Technical Advisory Group Recommendation

Description	Budget Estimate (\$)
Industrial Builders, Inc.	
<i>Change Order #6 (Asphalt Paving and Other Items)</i>	<i>\$55,605.75</i>
WP-42F.1N, 2 nd St Floodwall North of Pump Station – Asphalt Paving, BNSF Railroad Ties, Floodwall Cap, Traffic Control, Additional Differing Subsurface Conditions, and Balance Quantities

Change Order No. 06

Date of Issuance:	<u>5/25/2017</u>	Effective Date:	<u>5/25/2017</u>
Owner:	<u>Metro Flood Diversion Authority</u>	Owner's Contract No.:	<u>WP-42F.1N</u>
Owner's Representative:	<u>CH2M HILL Engineers, Inc.</u>	Owner's Representative Project No.:	<u>435534</u>
Contractor:	<u>Industrial Builders, Inc.</u>	Contractor's Project No.:	
Engineer:	<u>Houston-Moore Group, LLC</u>	Work Package No.:	<u>WP-42F.1N</u>
Project:	<u>Fargo-Moorhead Area Diversion</u>	Contract Name:	<u>Flood Control, 2nd Street North, North of Pump Station</u>

C-060-5

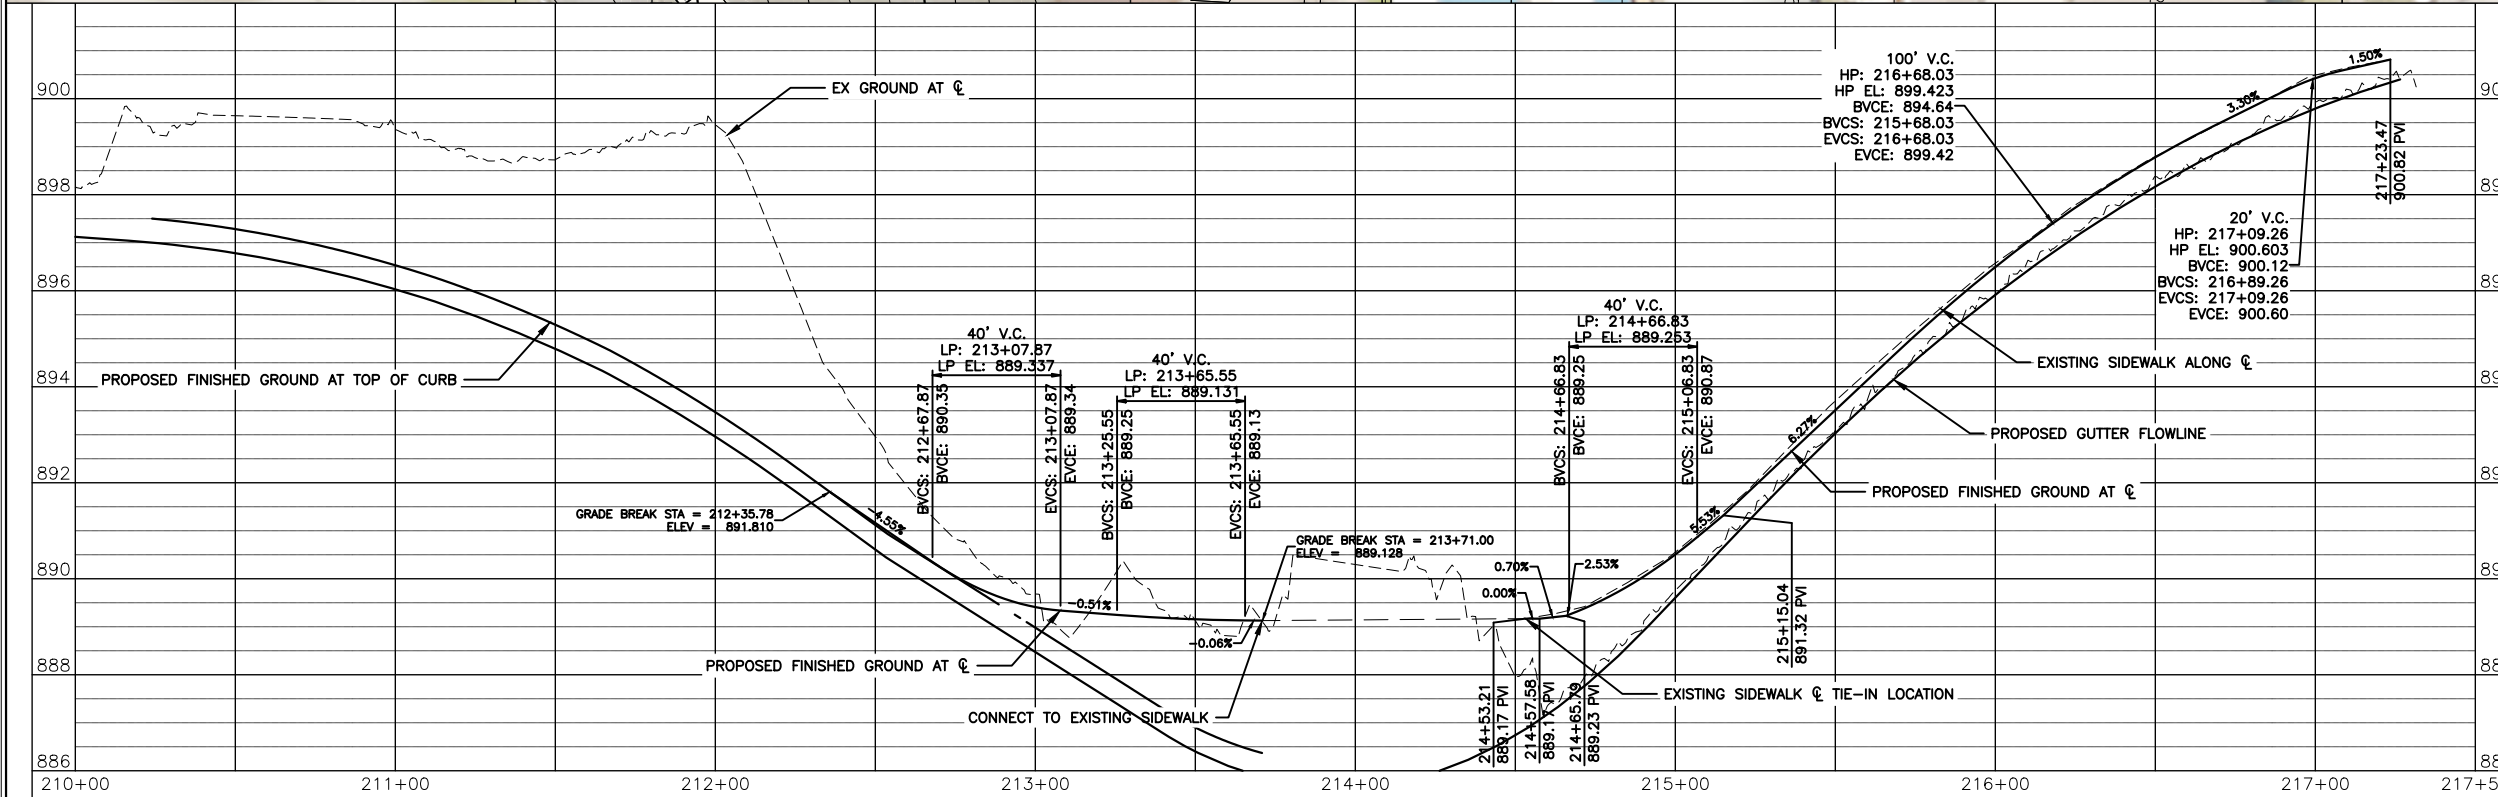
Incorporate all work specified in Work Change Directive No. 1 (asphalt paving, railroad ties, and traffic control), plus replacement plan sheets C-060-5 and C-060-6, into the Contract Documents. This increases the Contract Price by a total of \$39,360.05 as shown in the attached Change Order 6 Unit Price Schedule dated 5/25/17. There is no change to the Contract Times for the work included in this Work Change Directive.

- 1. Provide new asphalt pavement along the BNSF right-of-way to match the existing conditions prior to construction, and east of the MEPS building. Reference attached plan sheets and table showing quantity changes for the applicable unit price bid items.
2. Furnish and install railroad ties on the north edge of the new asphalt pavement along the BNSF right-of-way shown above. Reference attached plan sheets and table showing the anticipated new LS bid item for this work.
3. Provide traffic control to facilitate sidewalk installation at the base of the retaining wall that was postponed from last year.

- 1. Both asphalt requirements were changes after the project was designed and bid. BNSF required the pavement along their right-of-way during the BNSF permit period. The area adjacent to MEPS was originally expected to be restored as green space; however, the final purchase agreement with the property owner resulted in a change to pavement.
2. The railroad ties are associated with the pavement required by BNSF as discussed above.
3. Delay from the BNSF permit process caused the sidewalk work to be pushed from 2016 (when 2nd St was closed) to 2017. Since 2nd St is now open to vehicular traffic, the contractor requires a partial road closure to safely install the sidewalk.
